Department of Planning and Environment NSW

RE: NARRABRI GAS PROJECT - WATER IMPACT ASSESSMENT

**Table 7.11 Summary of parameters for each geological unit**

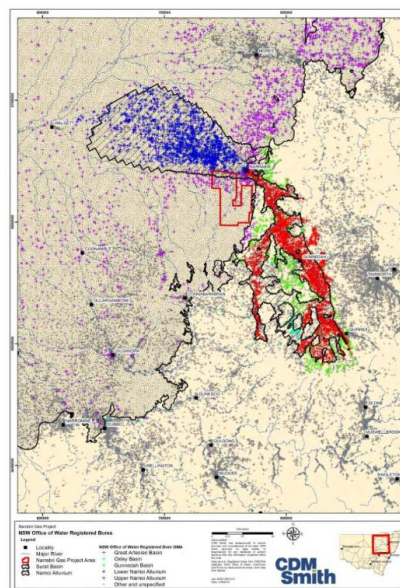
Santos EIS claims their modelling indicates there will be less than 0.5m drop in the Pilliga Sandstone aquifer because of the assumptions that there are 'relatively impervious rock layers' between the target coal seam and the aquifer. The vertical hydraulic conductivity values are too conservative. The Namoi Water Catchment Study Phase 2 conducted by Schlumberger indicates there is no such impervious layer:
